# Smog Check Performance Report

6/30/2017

This attachment to BAR's 2017 Smog Check Performance Report includes Chapter 3 (only) of the "Independent Review of 2016 Smog Check Performance Report," by Revecorp, Inc., with annotation (*in italics*) to show BAR's responses. Revecorp's bulleted comments refer to BAR's 2016 Smog Check Performance Report and to page numbers in that Report, while citations in BAR's responses refer to the current (2017) Smog Check Performance Report and the pages herein, reflecting BAR's consideration and/or adoption of many of the specific comments and recommendations. The entire Independent Review by Revecorp of the 2016 Report (without annotation) may be found in Attachment C.

**Figure 2: Scenario 1 and Scenario 2 Criteria  
Roadside ASM Tailpipe Failure Rates for Vehicles  
Within One Year of Failing Initial Smog Inspection Prior to Certification  
(Model Year 1976-99 Vehicles)**

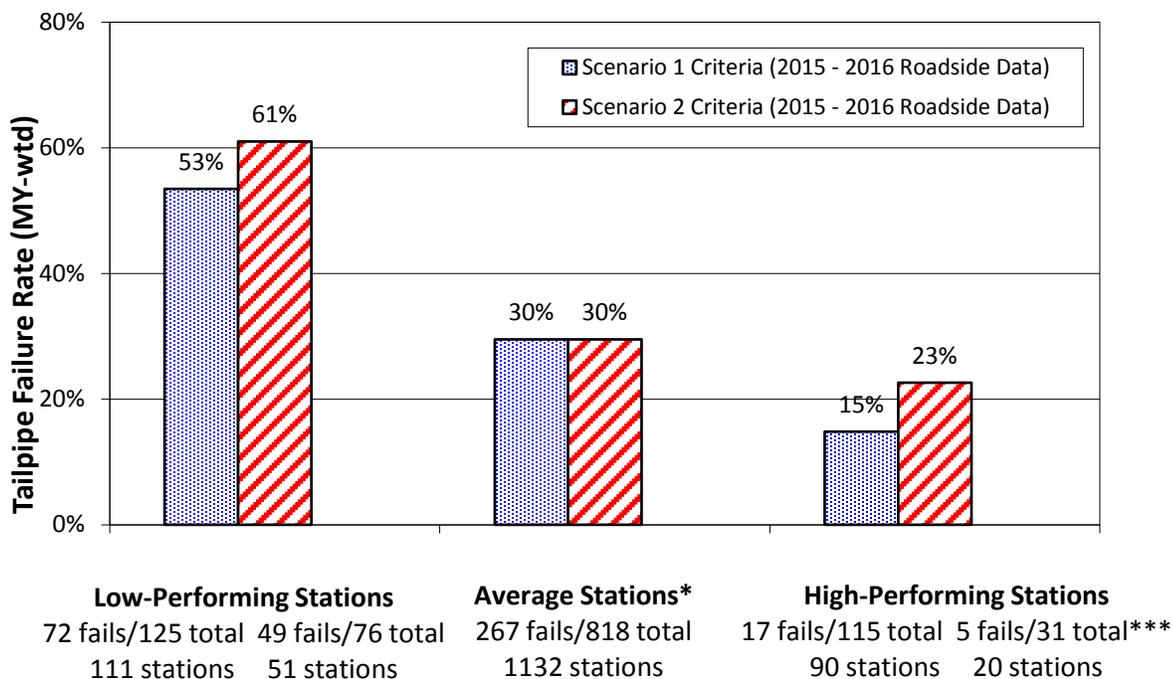
- Comment - Pages 6, 7 and 8 - Figures 1, 2 and 3 – Add error bars and sample sizes to the charts. Also, list the number of stations in each group and the number of inspections performed by these stations so their relative impact can be assessed.

*The numbers of stations, roadside tests and roadside fails in each group has been added to new Figure 2 (pg. 11). In addition, a new Table 2 (pg. 8) has been added which shows numbers of STAR, non-STAR and other stations, along with their respective total numbers of initial tests, failed initial tests, and failure rates. Error bars have not been added to the figure because of the complexity of mixing the weighted and unweighted vehicle counts. Instead, to provide insight into the associated uncertainties of roadside fail rates (and to provide insight into the contributing factors to roadside failures), BAR has provided (pp. 21-23, including Figures B-1 and B-2) initial logistic regression modeling results of roadside fail rates as a function of certifying station FPR scores and time between Smog Check certification and the follow-up roadside test. The vertical range of the shaded band shown in each figure represents the 95% confidence interval for the estimated probabilities of roadside average fail rate. These roadside failure probabilities account for vehicle model year, time between certifying Smog Check test and roadside test, prior initial test result, and FPR. The regression-based estimates of*

**Figure A-1**

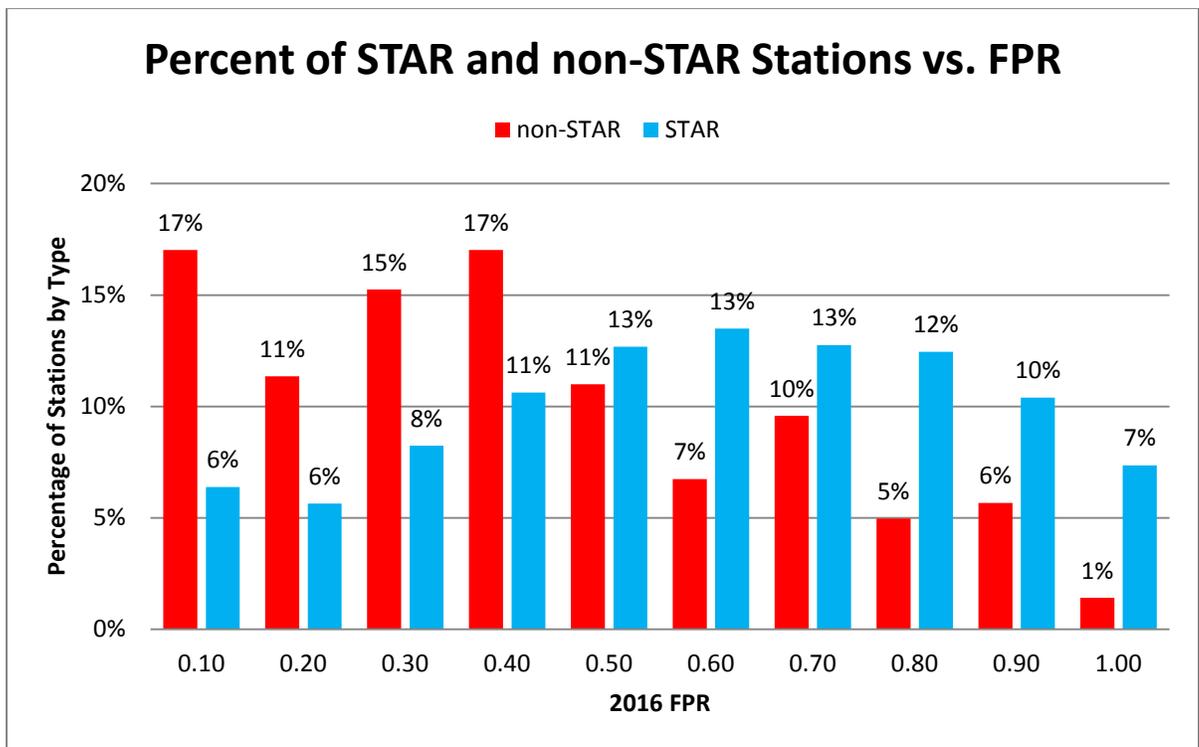
- Comment - Page 7, top paragraph – What fraction of the STAR stations is low-performing? How many low-performing Smog Check stations are longer-term, low-performing and how many are new to the STAR program?

The histogram in Figure A-1 (below) shows the percentages of STAR and non-STAR stations by FPR in calendar year 2016. The mean FPR score for STAR stations is significantly

greater than that for non-STAR stations (even though the more failure-prone older vehicles are directed exclusively to STAR stations). The threshold FPR level at which STAR stations may lose certification is 0.10 and the threshold for non-STAR stations to be certified as STAR (provided that all other requirements are also met) is 0.40. These metrics were selected to provide incentive for testing volume to move from stations having FPRs that are below average, that is, stations which have an FPR of less than 0.50 (like most of the non-STAR

stations) to stations that have an FPR greater than 0.50 (like most of the STAR stations). Finally, it should be noted that only stations which have earned an FPR score are shown in the figure. Stations which have not performed any BAR-97 tests or have an insufficient number of tests to provide a reliable FPR score are excluded from the figure.
